**CITY OF SAINT PAUL
HERITAGE PRESERVATION COMMISSION STAFF REPORT**

FILE NAME: 500 Cedar Street, Central Presbyterian Church
DATE OF APPLICATION: August 4, 2015
APPLICANT: Fluryanne Leach, Central Presbyterian Church
OWNER: John Lee, President of the Corporation of Central Presbyterian Church
DATE OF HEARING: August 27, 2015
HPC SITE/DISTRICT: Individual Site—Central Presbyterian Church
CATEGORY: Pivotal
CLASSIFICATION: Building Permit
STAFF INVESTIGATION AND REPORT: Allison Suhan
DATE: August 21, 2015

File #15-036

HPC Public Hearing 8-27-15, Item IV.A.

DECRA® Shingle XD®

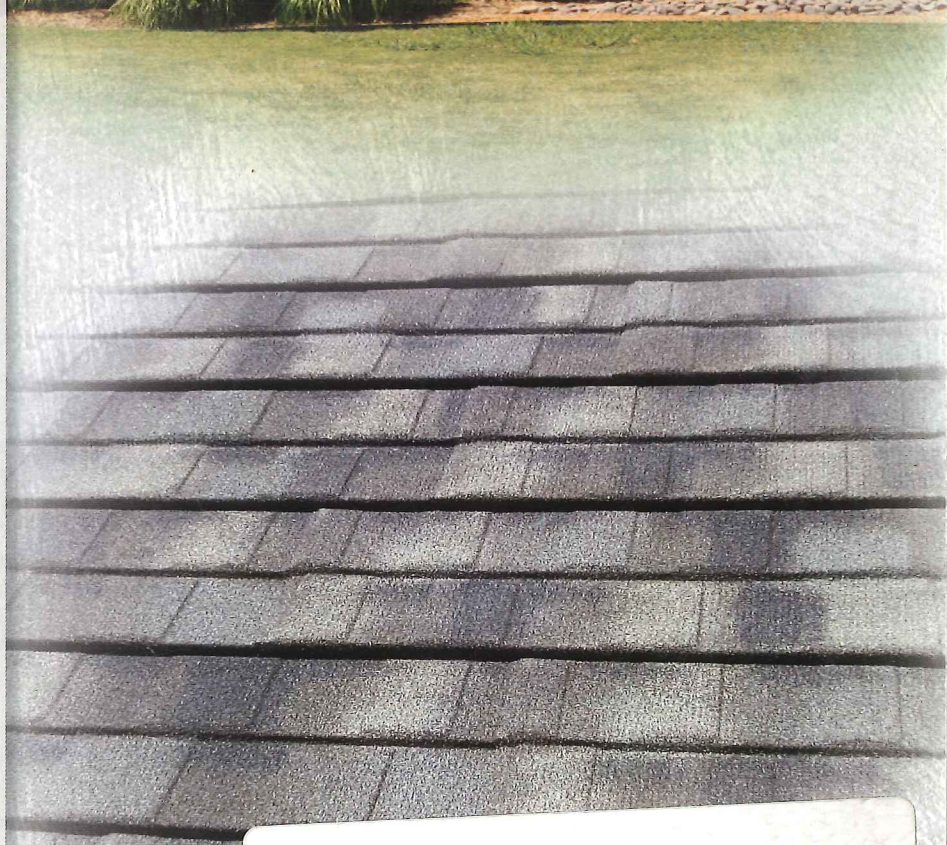
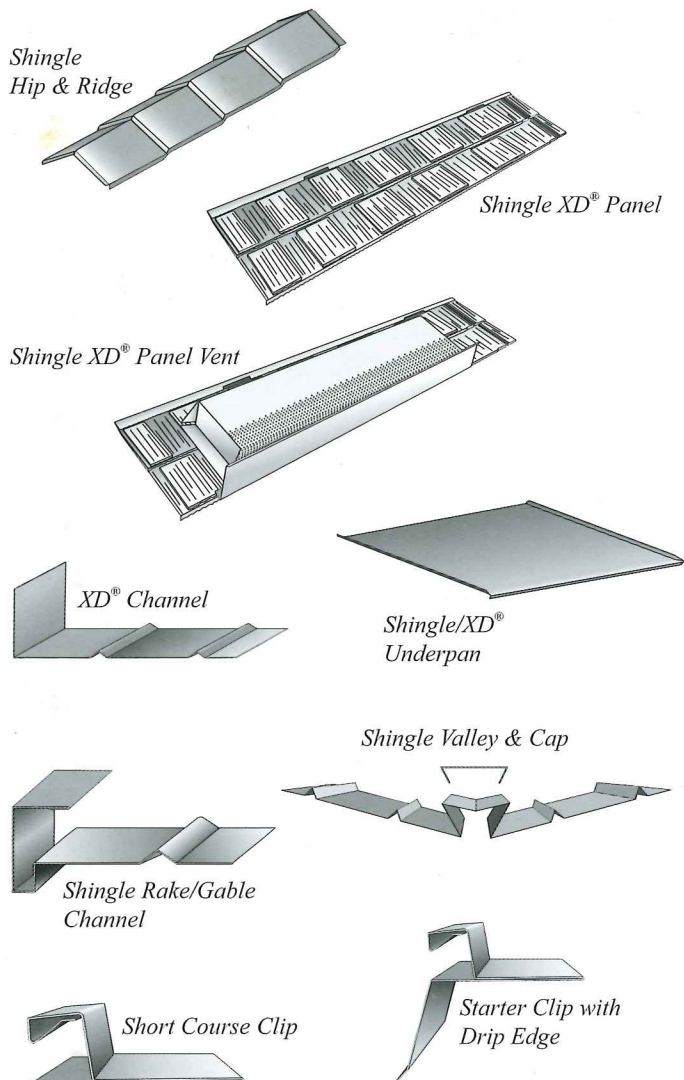
3. *Standard #6 states “Deteriorated historic features shall be repaired rather than replaced. Where the severity of deterioration requires replacement of a distinctive feature, the new feature shall match the old in design, color, texture, and other visual qualities and, where possible, materials. Replacement of missing features shall be substantiated by documentary, physical, or pictorial evidence.”* The DECRA stone-coated metal roofing in ‘natural slate’ color does not resemble slate, nor does it match the current asphalt shingles in profile, size, *design*, or *material*. The exposed profile of the proposed metal roof does not relate to the details of a slate or asphalt shingle roof. The DECRA Shingle XD’s stamped pattern exposure relates to that of an average

asphalt shingle. The width of the individual stamped raised portions of the DECRA panel pattern are half the width of slate and the thickness of the panel is over 13 times thinner than slate. The panel texture also has an exaggerated and rough profile that does not relate to the smooth texture of slate, but may appear visually similar to an asphalt shingle. The proposed product does not comply with this guideline.

4. *The Standards state that if using the same kind of material is not technically or economically feasible (in this case, slate), then a compatible substitute material may be considered.* The DECRA metal roofing panel is not a compatible substitute for a slate roof, synthetic slate, or architectural asphalt shingle. The HPC reviewed and approved GAF Slateline asphalt shingles for Central Presbyterian Church in 1993 that were found to be a good approximation of the color and texture of a slate roof in an asphalt shingle. HPC staff could administratively review and approve a synthetic slate or architectural shingle in a profile and color relating to slate. Cost estimates for alternative roofing materials were not provided by the applicant. The DECRA Shingle XD is not a compatible substitute material to slate or the existing asphalt shingles, thus it does not comply with this guideline.

Based on the findings, staff recommends denial of the building permit application to reroof Central Presbyterian Church with a stone-coated, steel roof in 'natural slate' color at 500 Cedar Street.

Staff could administratively review and approve an application to reroof the church with slate, a roofing product that complies with The Secretary of the Interior's Standards for Rehabilitation and better relates to slate material in color, texture, material, size, and profile, or the replacement with the GAF Slateline as previously approved.
